**FINAL DECISION DOCUMENT
FOR THE INTERIM RESPONSE ACTION
AT THE
MOTOR POOL AREA
ROCKY MOUNTAIN ARSENAL
FEBRUARY 1990
CONTRACT NO. DAAA15-88-D-0022/0002
VERSION 4.0**

Re: Rocky Mountain Arsenal (RMA)
Proposed Decision Document for
the Interim Response Action at
the Motor Pool Area, November
1989.

**RESPONSE TO EPA'S COMMENTS
ON THE PROPOSED DECISION DOCUMENT
FOR THE INTERIM RESPONSE ACTION
AT THE MOTOR POOL AREA, VERSION 2.0
NOVEMBER 1989**

Figure 2-3

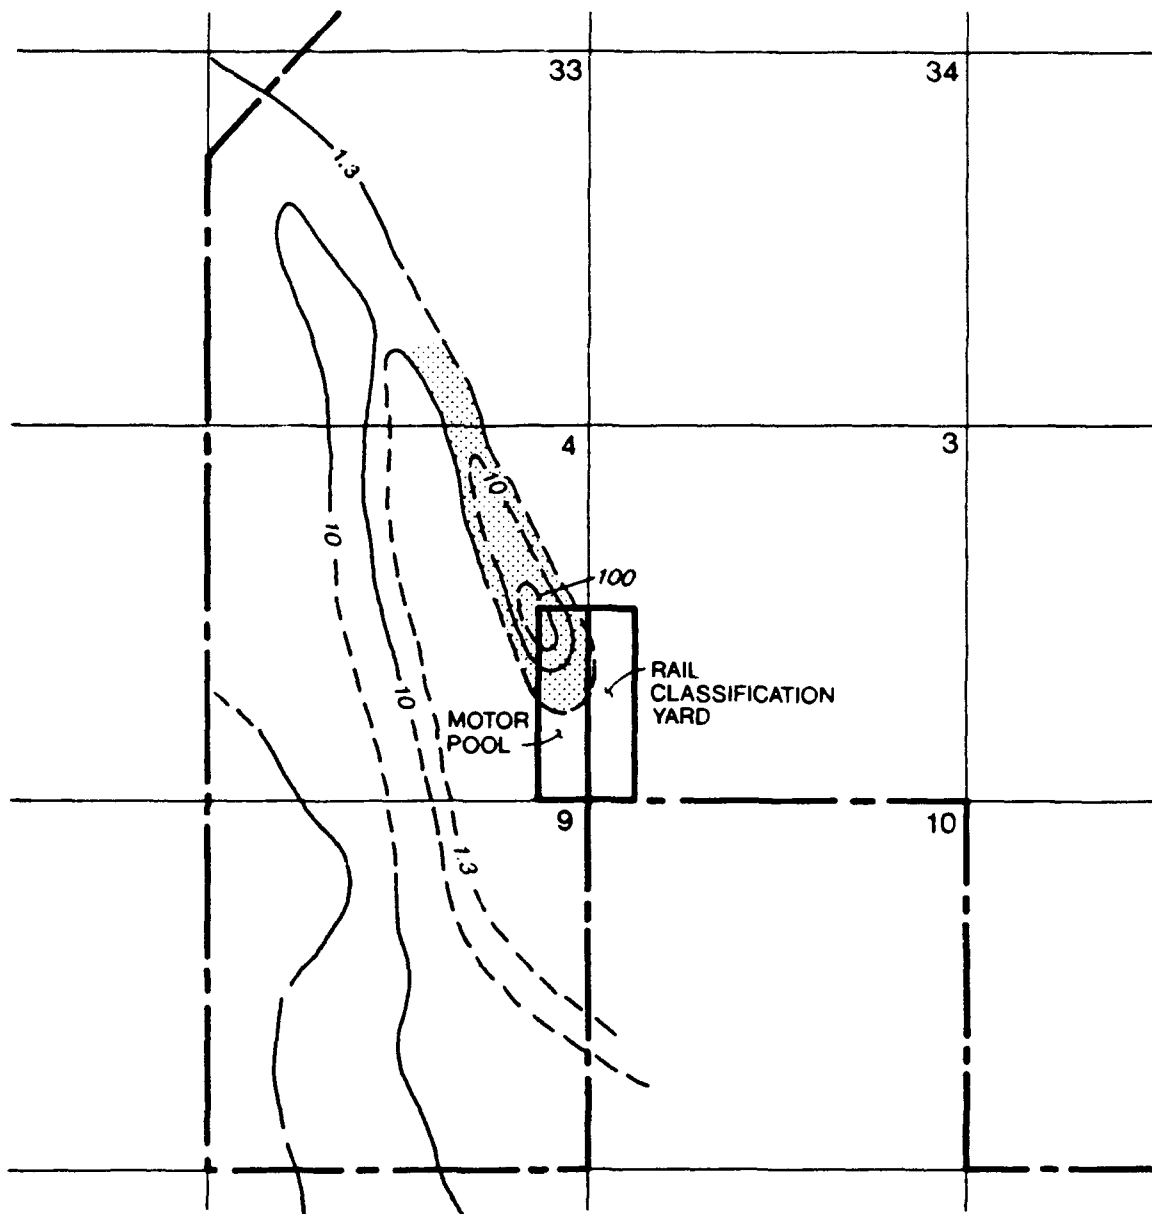
Comment 2: Units of concentration from the soil gas survey should be applied to the concentration lines on Figure 2-3.

Comment 7: In Figure 2-3, the soil gas concentration contours do have units. If the units are ug/l gas, then there appears to be an approximate order of magnitude discrepancy between values reported in this study and the Ebasco investigation (see Figures 2-17, results of field and laboratory investigations conducted for the remediation of other contamination sources).

Response: The figure has been revised.

Response: Soil gas is a fairly qualitative method of identifying possible sources of contamination. Both investigations indicate a contamination source in the same vicinity. However, soil contamination concentrations cannot be quantitatively inferred from soil gas results.
